REPORT AMENDED BY STAFF 7-8-85  
**CITY PLANNING COMMISSION**

- APPLICATION:**
- A. Negative Declaration
  - B. Special Permit to construct a 60,000+ square foot television broadcast studio and a 300 foot high off-site transmission tower.
  - C. Variance to waive 35 required parking spaces.

**APPLC. NO.** P85-257

# SITE PLAN

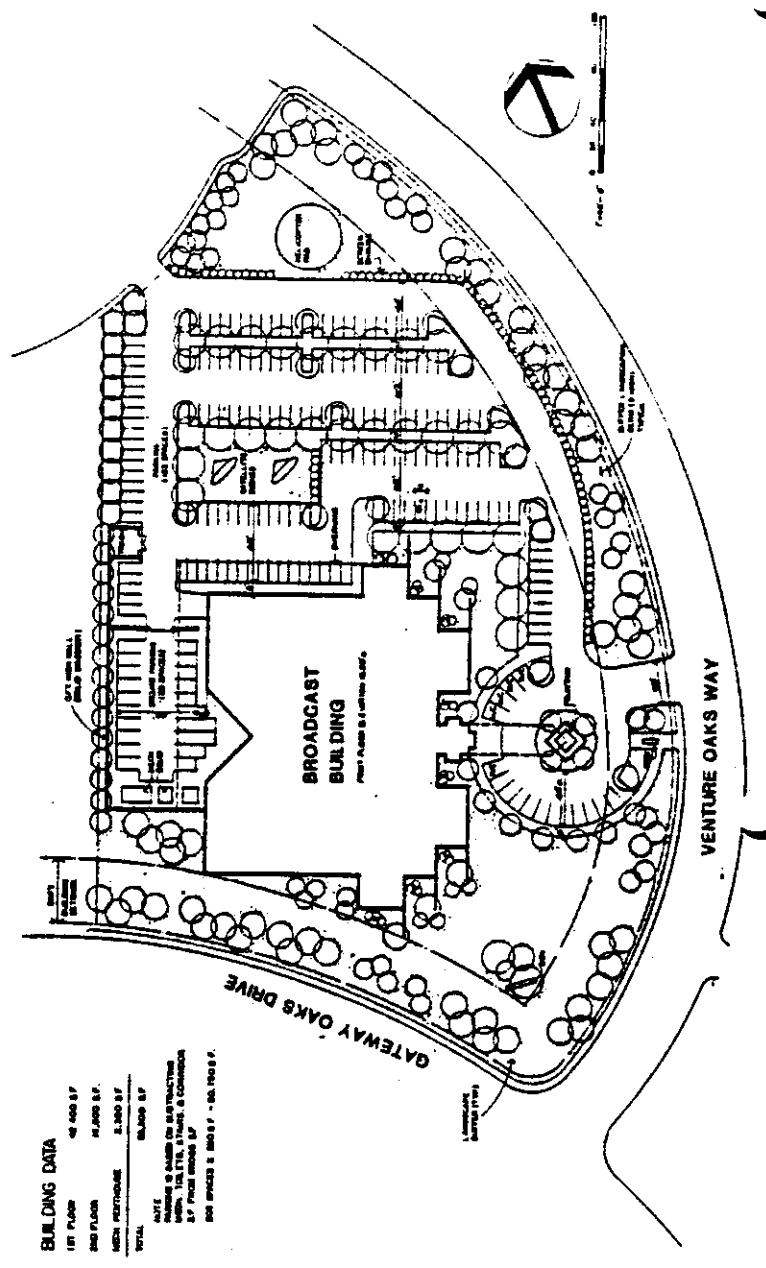
- F. Parking/Circulation: The applicant's site plan indicates that the parking calculations have been based upon the net square footage and not the gross square footage as is required by the Zoning Ordinance. The proposed broadcast facility contains 59,500 square feet of gross floor area which, at a ratio of one space per 250 feet of gross floor area, would require that 238 parking spaces be located on site. The site plan indicates that only 203 spaces have been provided, or 35 spaces less than required by ordinance. *Staff feels that the studio can be classified as a warehouse use which would require six parking spaces and reduce the overall parking to 216 or 13 more spaces than are provided on site. Staff feels that warehouse classification for the studios is appropriate only if both studios are utilized for non-audience participation programming. In the event that an audience participation shows are broadcast from either studio, then parking must be calculated at a higher ratio. (staff added)*

The applicant has not indicated what, if any, unique circumstances exist which warrant the granting of a parking variance. A redesign of the parking configuration (30% compact spaces and utilization of helipad site) would in all likelihood provide the necessary parking ratio. Staff recommends that the parking variance be denied.

It appears that the handicapped parking spaces shown on the site plan will not meet code. All handicapped parking must be redesigned and/or relocated so as to comply with all applicable standards.

As proposed, a corner of the building would extend into the height restricted area along Gateway Oaks Drive. Staff recommends that the site plan be revised to locate the building outside of the height restricted area or at least that portion of the upper floors of the building which are greater than 25 feet in height.

- L. Helicopter Landing Site: Although a helipad is shown on the site plan, the applicant is not applying for the helipad use at this time. At a later date the applicant may choose to submit a special permit application for the helipad. Staff would like to recommend that the helipad be located at another site. The proposed helipad site is inappropriate due to its location adjacent to Venture Oaks Way, the future/proposed office uses adjacent to the subject site and the residential uses being developed to the west of the site.

1. A revised final site plan, detailed landscape and irrigation plans shall be submitted to the Planning Director for review and approval, prior to issuance of building permit, which incorporates the following changes:

- a. detailed landscape plan for the entire project site;
  - b. four-foot high berms along the street frontages;
  - c. relocation of the building so that it does not encroach into the height restricted area along Gateway Oaks Drive;

- d. 238 on-site parking spaces and 12 bicycle storage lockers.
2. The trash enclosure facilities shall be constructed in accordance with the following criteria:

# LANDSCAPE PLANS

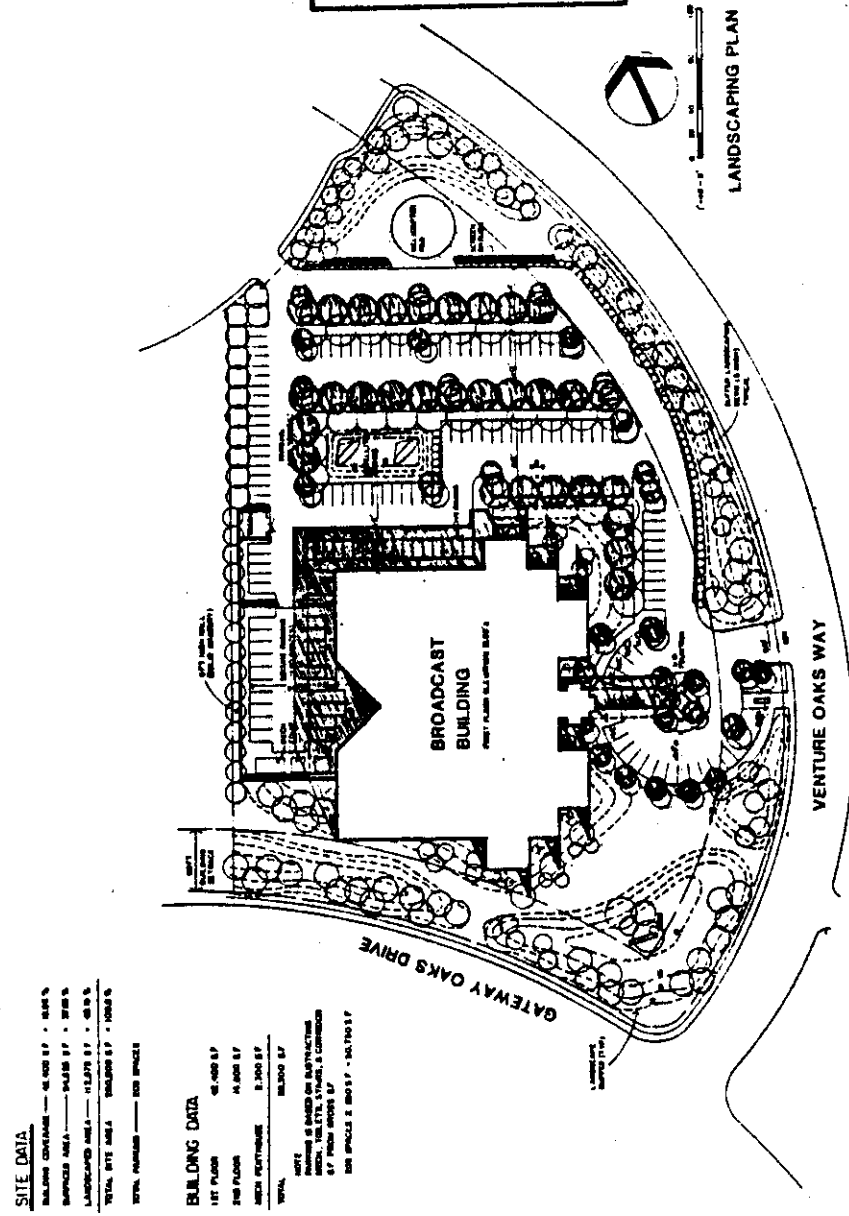
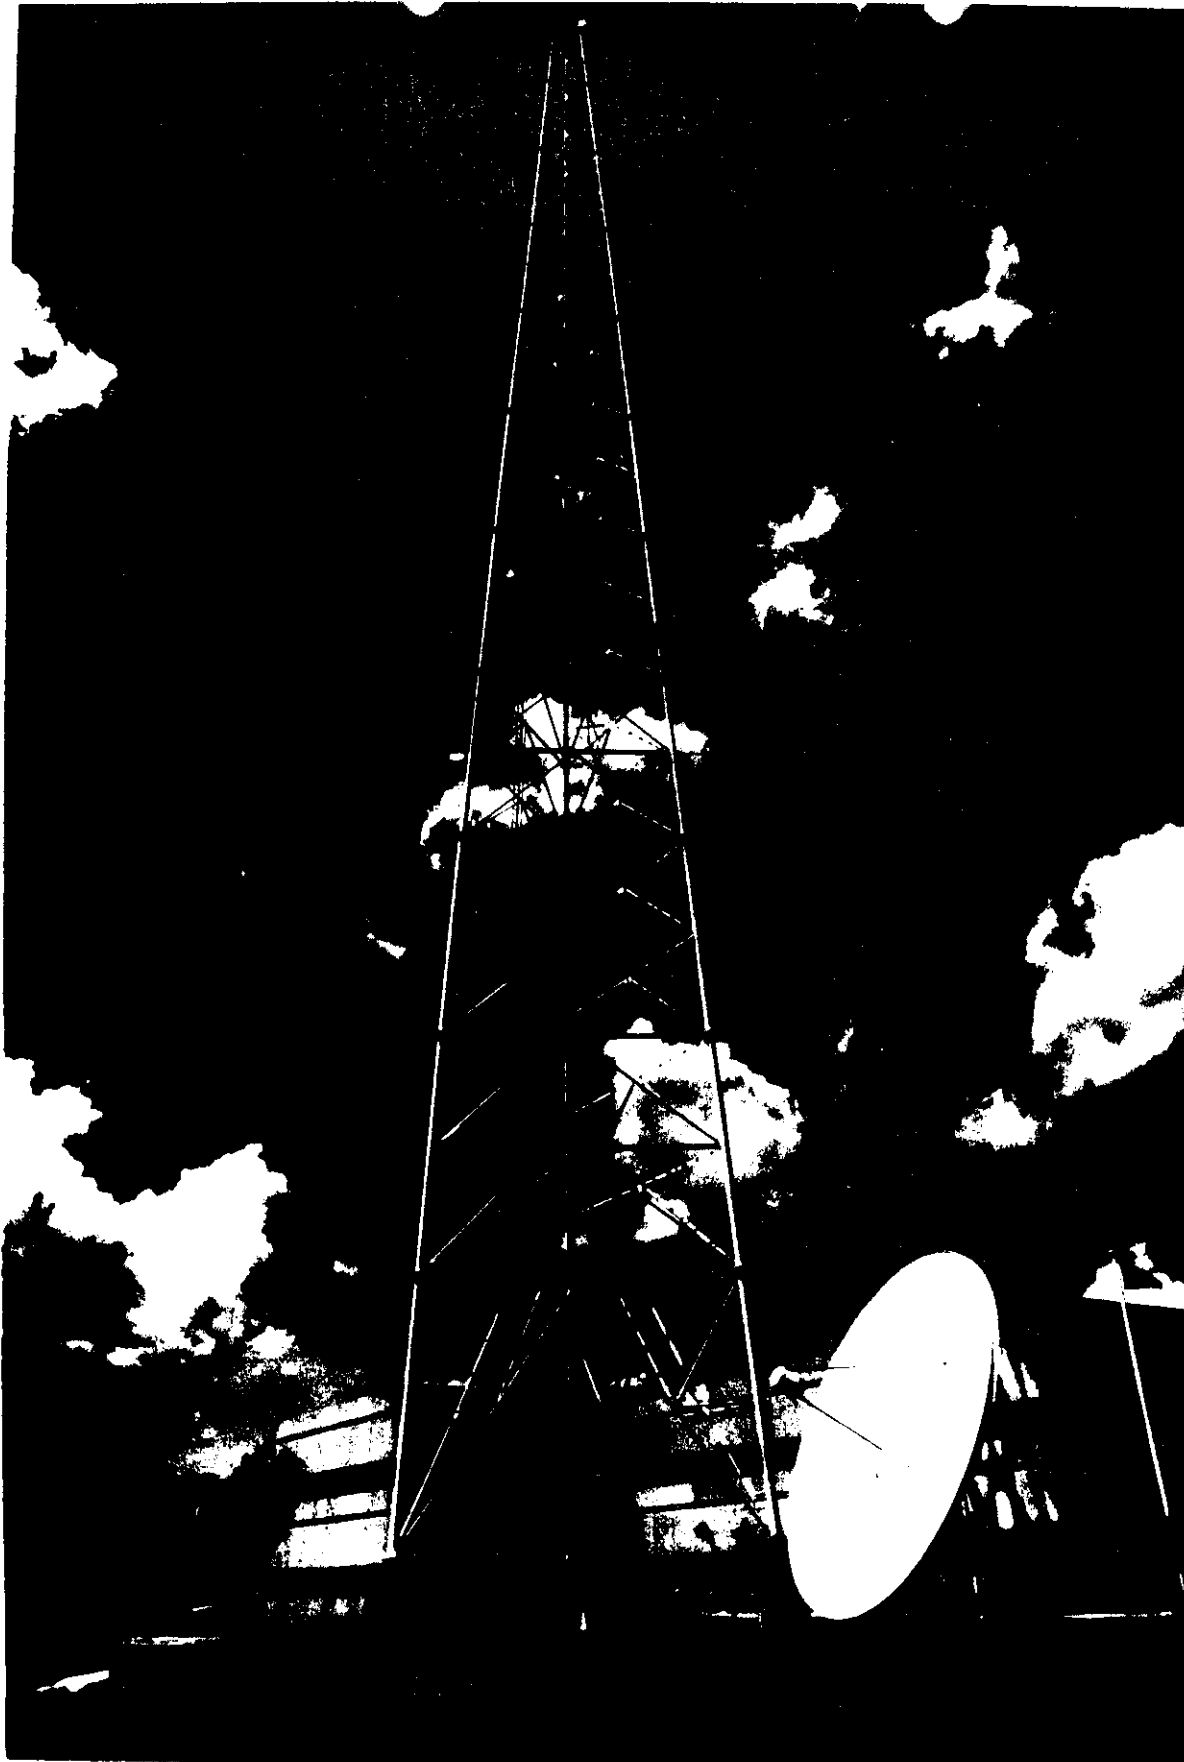
- G. Landscaping: The applicant's landscaping plan indicates that 45% of the site will be landscaped. The site plan indicates that the applicant has provided for the required 50 foot and 25 foot landscape setback on Gateway Oaks Drive and Venture Oaks Way, respectively. All landscape setback areas shall be bermed (minimum 4 ft. high) and all berms shall be landscaped with predominantly evergreen trees, shrubs and ground cover. In addition, the parking lot must be planted with trees so that at least 50% of the parking lot will be shaded. A complete landscape and irrigation plan must be submitted to the Planning Director for review and approval prior to the issuance of building permits.
